Tar Precipitator Replacement
Dated: 1991

SUBJECT: REPLACE (3) TAR PRECIPITATORS

SPECIFICATION
FOR THE REPLACEMENT OF
THREE COKE OVEN GAS TAR PRECIPITATORS

SPECIFICATION NO. II-4339

Plan View

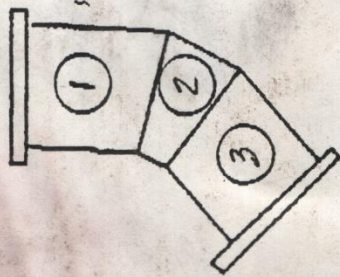
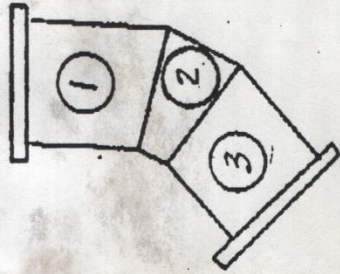
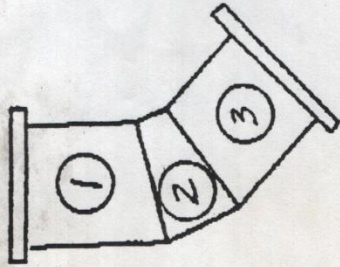
THE GAS INLET SPOOLS FOR THE TAR PRECIPITATORS HAVE BEEN INSPECTED. THE RESULTS OF THE THICKNESS TESTS ARE ATTACHED. ALSO, THE EXTERIOR CONDITION OF THE SPOOLS IS SATISFACTORY AND THERE ARE NO FIBERGLASS OR WELDED REPAIR PATCHES. THEREFORE, ENGINEERING RECOMMENDS THAT THE REPLACEMENT OF THE INLET SPOOLS IS NOT TO BE INCLUDED AS PART OF THE TAR PRECIPITATORS PROJECT.

ORIG = 5/16" = .3125
